| Project                      | IEEE 802.16 Broadband Wireless Access Working Group < <a href="http://ieee802.org/16">http://ieee802.org/16</a> >   |  |
| Title                        | Enhanced Mode Selection Feedback header   |  |
| Re:                          | This is a response to a Call for Comments on IEEE P802.16e-D5   |  |
| Abstract                     | we propose to enhance the Mode selection Feedback header to support extended codeword and dual selection demands  |  |

*[Change the following new Figure 20b – Mode Selection Feedback header. in page 15]*

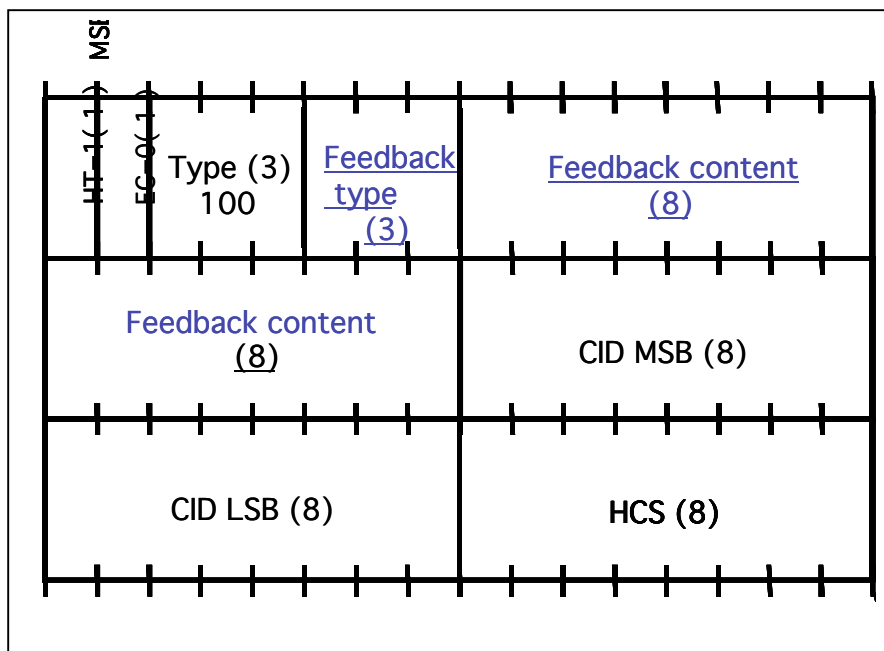
We suggest the new header format to support extended codeword and dual selection demands
